Far Fabbri Crazy Dance structure component failure

TECHNICAL BULLETIN

Title:	CRAZY DANCE	
Bulletin N°.	13.000.01	
Release Date:	21 June 2017	
Effective Date:	Immediately	
Reported by:	Mr Enrico Fabbri	
Ride Name:	CRAZY DANCE	
Manufacturer	FAR Fabbri (Italy)	
Type/Version:	ALL	
Affected Serial N.:	ALL	
Final Instruction:	Recommended

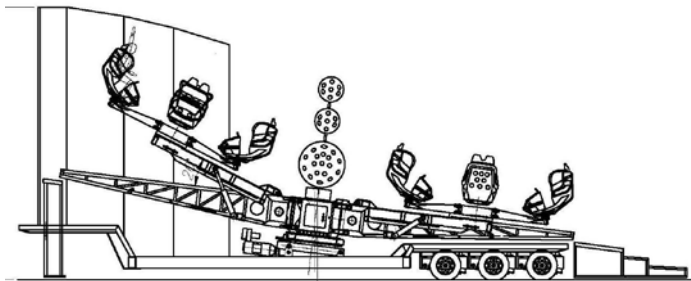
Cracks of main structure of steel structure holding the passenger's vehicles.

We have been informed that a steel structure of the "satellite" which holds the passenger's vehicles relates to the equipment named "Crazy Dance" has broke down near vehicle connection. Results are that passenger's vehicle was almost completely detached. Failure of any of these structural components could results in serious injury passengers, employee and bystanders.

We have not been able to see the parts, however based on the photos and information received, we point out:

- (a) The attraction was in operation for approx. 15 years
- (b) Cracked surfaces show strong evidence of rust, meaning that cracks in steel were in action since long time
- (c) Fresh cracked surfaces (the one in shiny color in the picture) show that at the moment the structure collapsed only a very small portion of the steel section was remaining
- (d) Steel parts were painted in black color (more difficult to see cracks on materials)

These conditions can be the results of excessive stress generated during the operation of the Equipment. We also remind that operators should not let the Main Plate and the Satellites run over the maximum speed limits established in the original manual instructions, furthermore the direction of rotation of the Main Plate should be always opposite of the direction of rotation of the Satellites.

Here enclosed some photos of the damaged components

1. **Immediately:** Visual inspection of these components; then a weekly visual inspection
2. **As soon as possible:** Non Destructive Test (NDT) of these components, as minimum every three year if the equipment has less of 10 years in operations; Non Destructive Test (NDT) of these components, as minimum every year if the equipment has more than 10 years in operations
3. **Monthly:** Check of the maximum speed of the Main Plate and Satellites
4. Any additional inspection of other components related or joint to these parts

It is our opinion that these components are subjected to heavy alternative stress, therefore the resistance to fatigue is less than 35.000 hours. For this reason we believe that owners/operators should consider to replace the "Satellites" after 15 years of operation. The repair of such heavily cracked steel structure, for example by re-welding the pieces together, is here strongly not recommended.
